Town of Hilton Head Island Regular Design Review Board Meeting

August 9, 2016

AGENDA

Issue / revisions	
1	
2	
3	
4	
5	
6	
07-26-16	FINAL DESIGN REVIEW
15047	
sklarcodeesign TAM	sklarcodeesign TAM
ELEVATIONS

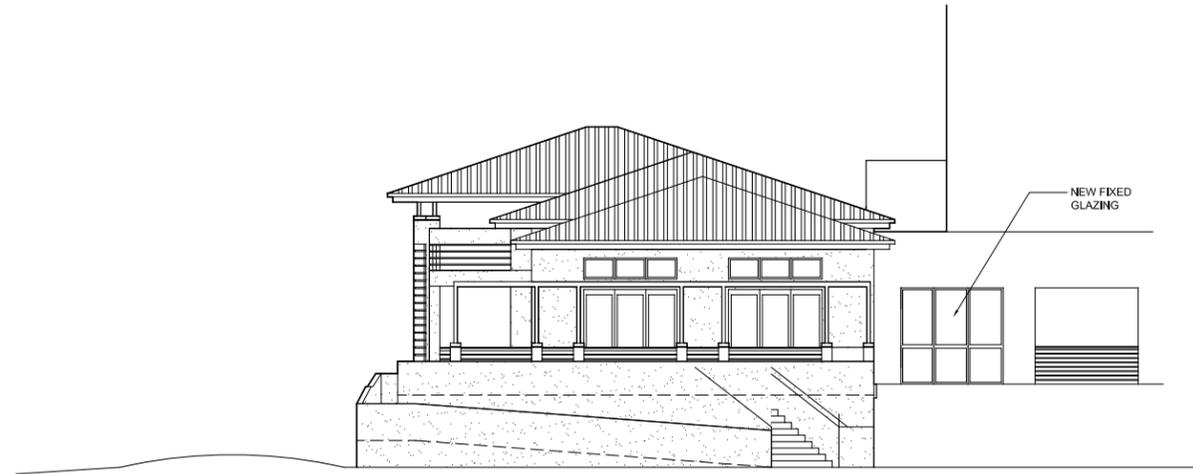
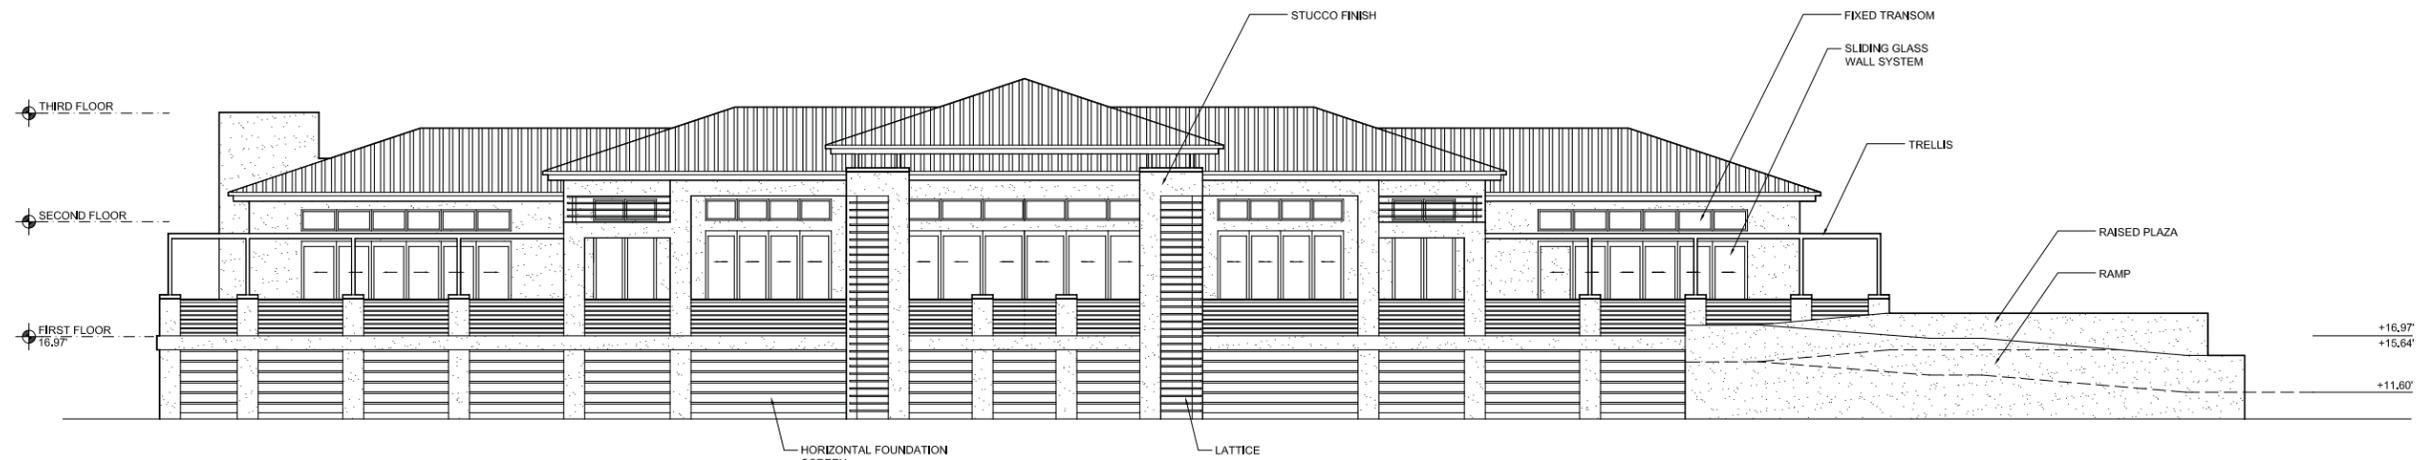
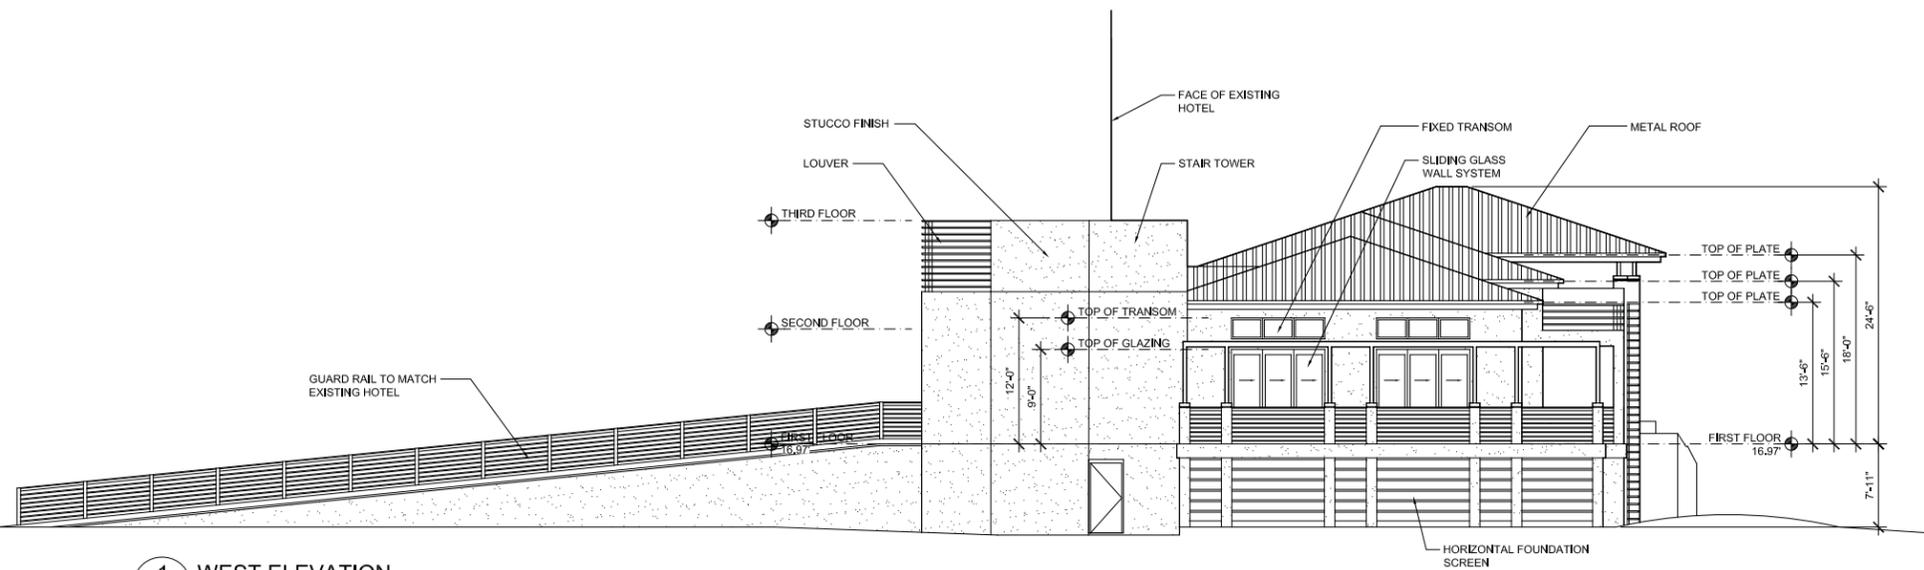
1. Submit wall sections and details including trellis detail.
